BID ADDENDUM NO. 1

Date of Addendum: January 4, 2024
Issued for Bid Date: December 18, 2022
Client Name: Eastchester Union Free School District
Project Name: 2022 Capital Bond Project, Phase 3
SED Project No.: Anne Hutchinson Elementary School: 66-03-01-03-0-001-023
Eastchester Middle / High School: 66-03-01-03-0-003-031
MEMASI Project No.: 102-2301
Contracts: Contract No. 1 – General Construction (GC)
Contract No. 2 – Mechanical Construction (MC)
Contract No. 3 – Electrical Construction (EC)
Contract No. 4 – Window Construction Work (WC)

MSHS S-101

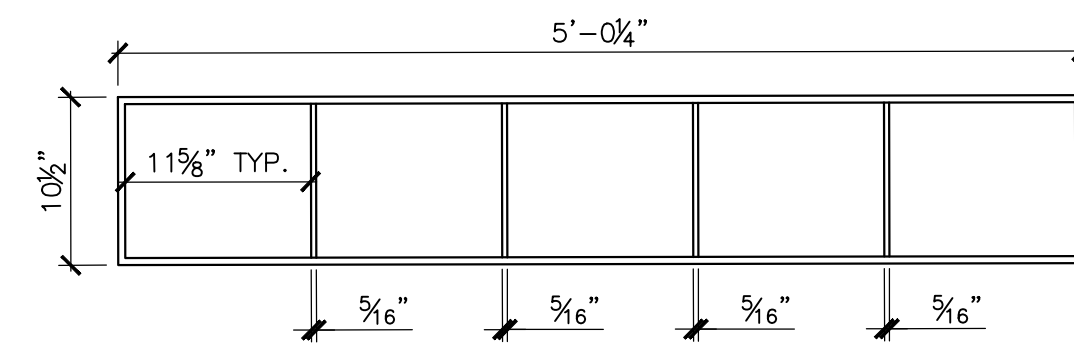
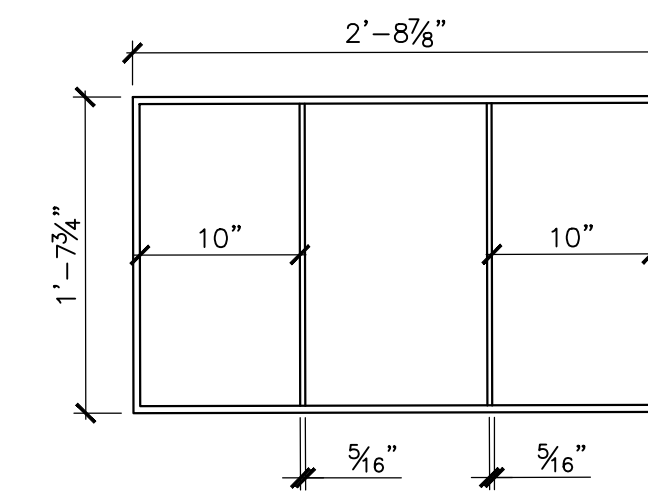
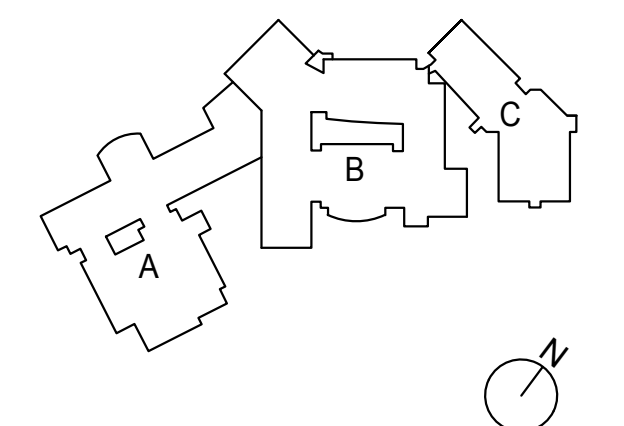
- a. Drawing S-101 was included in the DRAWING LIST spec but missing from the drawing set.

LS003

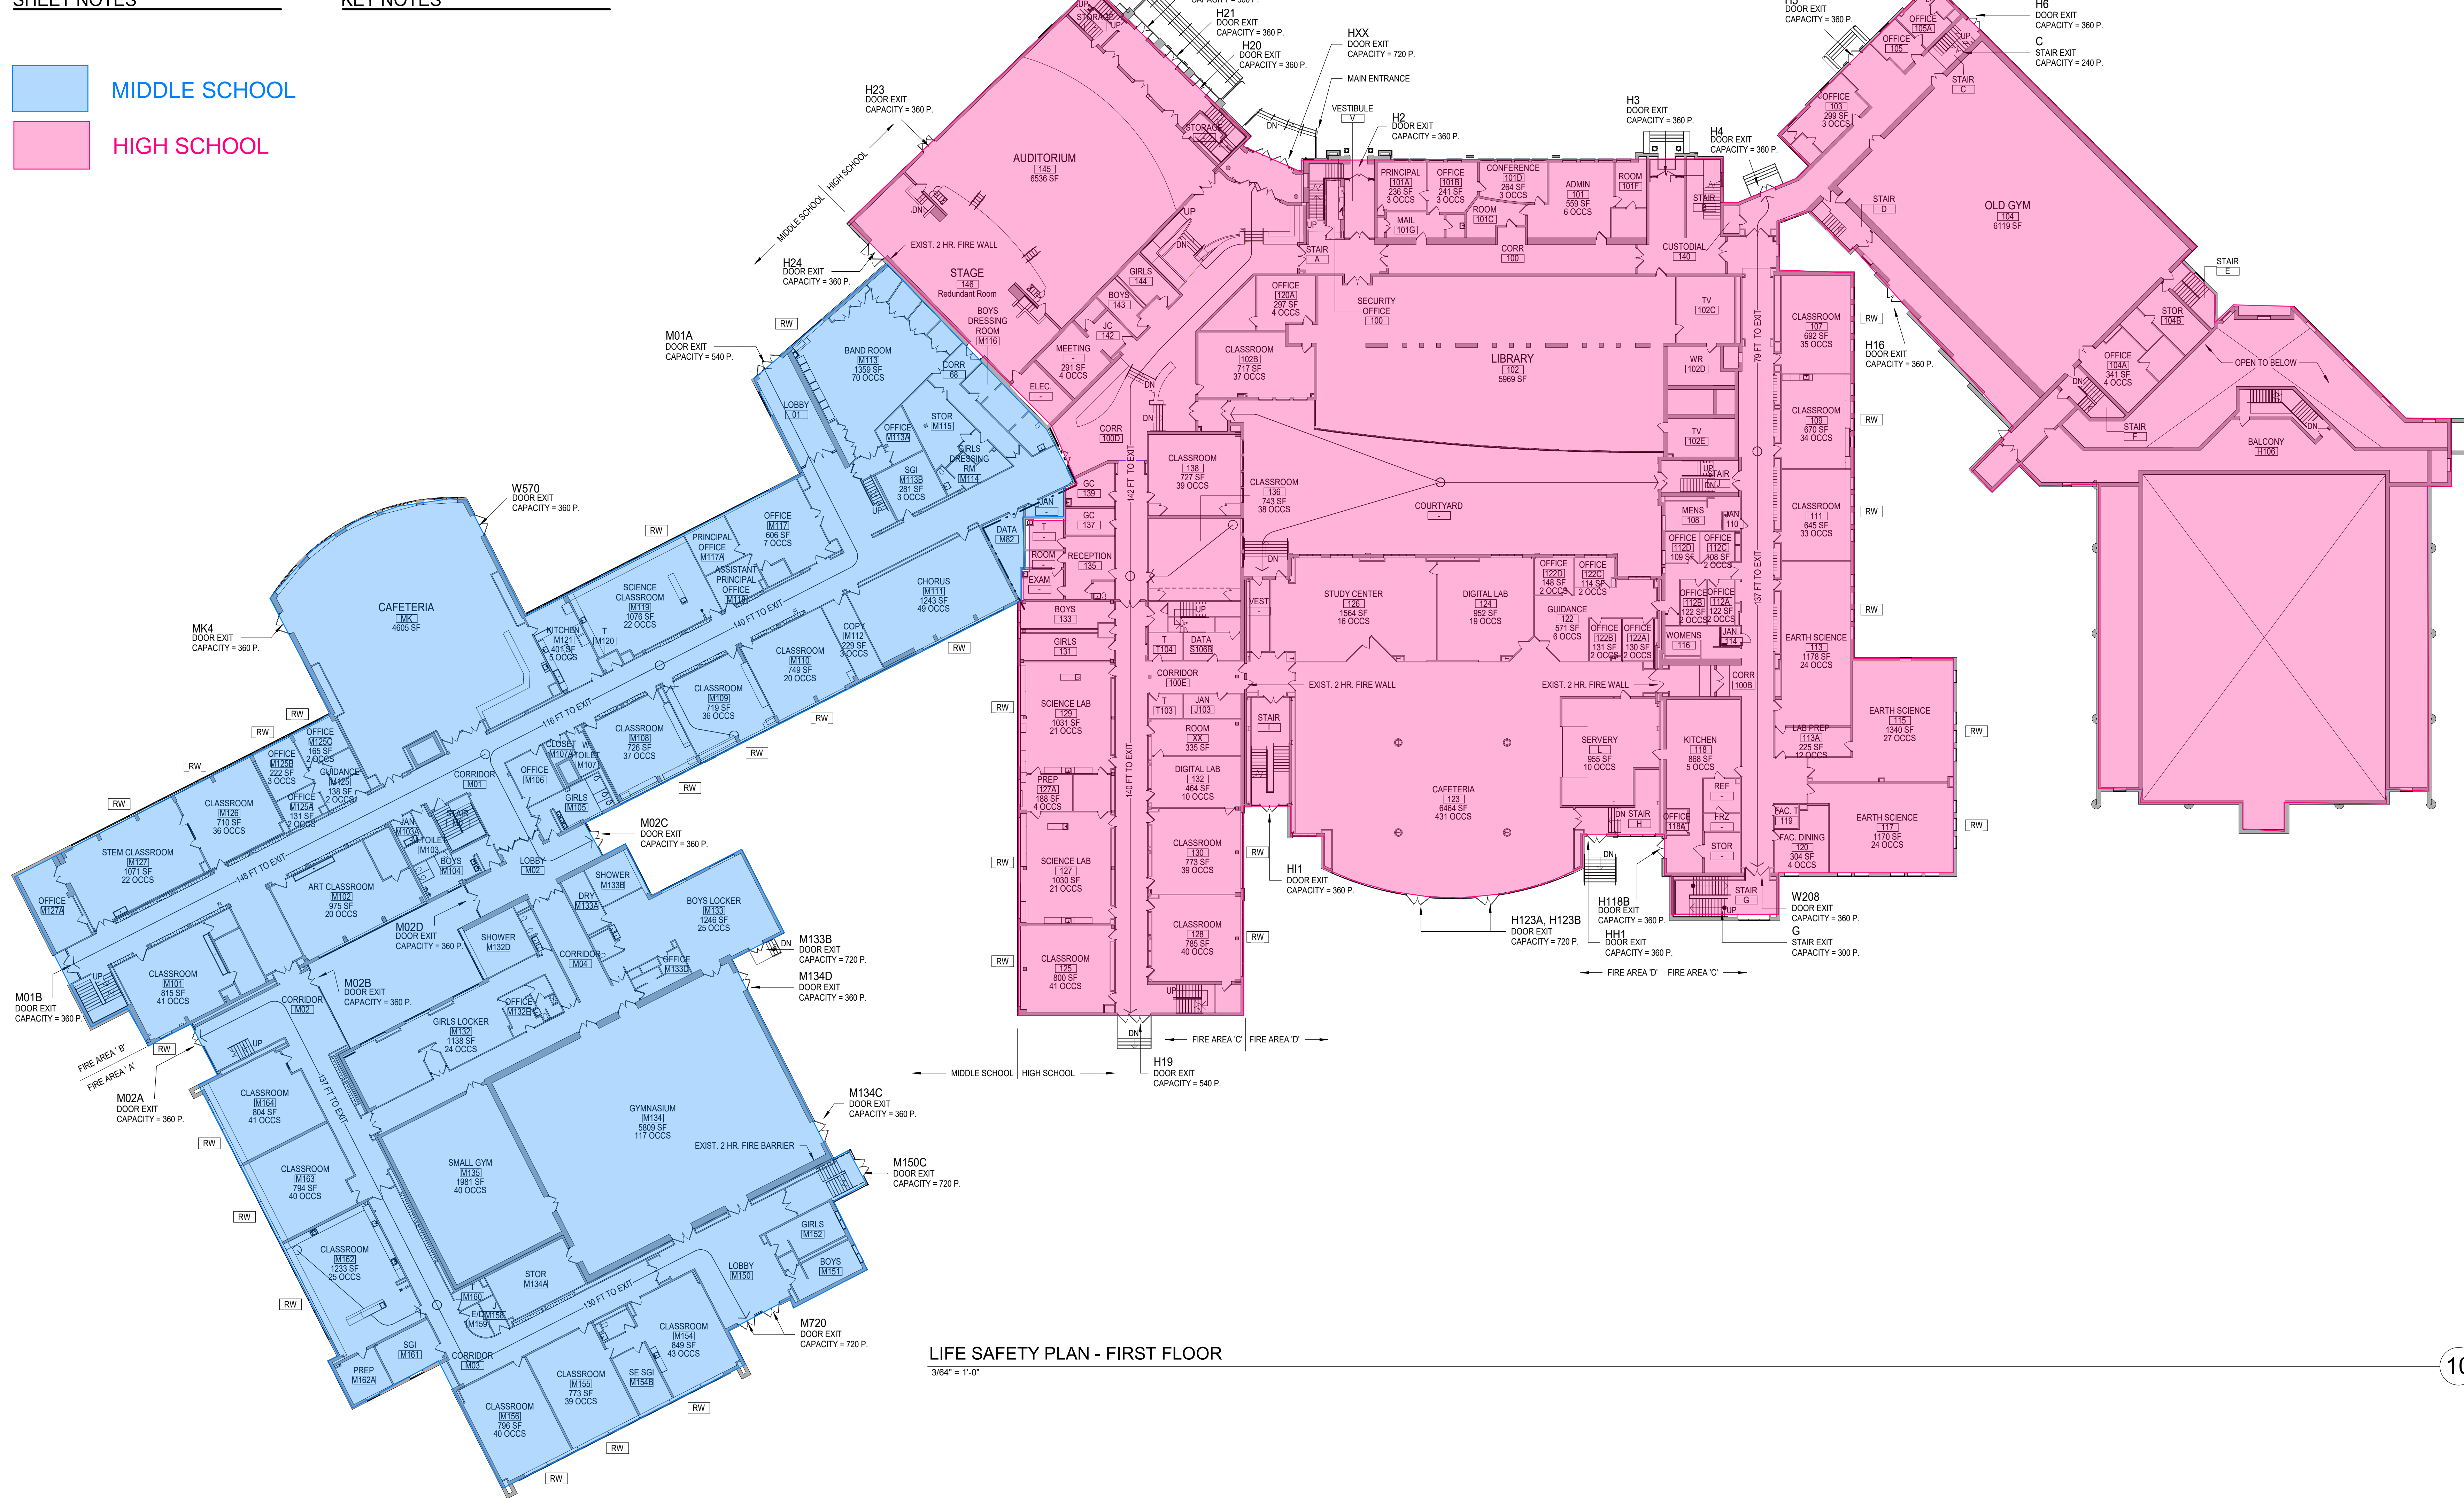
- a. The drawing is issued to clarify which building is the Middle School and which one is the High school. There are no changes to the drawing.
